**SIB 66 01 14**

SERVICE ACTION: Keyless Ride Radio Keys - Bulletin 66 001 14 (026)R

Subject: Keyless Ride Radio Keys

Model: K 1600 GTL Exclusive (K48)

2: Procedure for destroying radio keys with faulty software

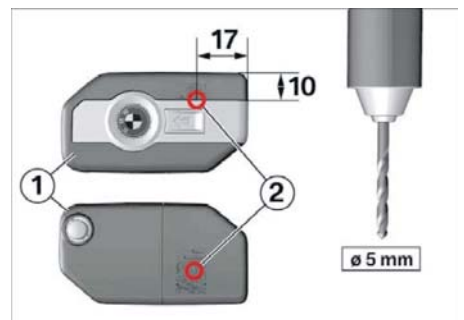
In order to avoid the possibility of confusion and prevent the radio keys with faulty software from being returned to customers, both radio keys must be destroyed and disposed of in the appropriate manner. Even radio keys with the faulty software that have always worked faultlessly can fail at any time. Under no circumstances should these keys be handed back to the customer as spares.

- Remove the battery from faulty radio key (1). (see riders manual)
- Clamp the radio key in a bench vice and drill a hole through it at destruction point (2) with a drill bit.

Technical data	
Drill-bit diameter	5mm
Destruction point (2)	17mm x 10mm
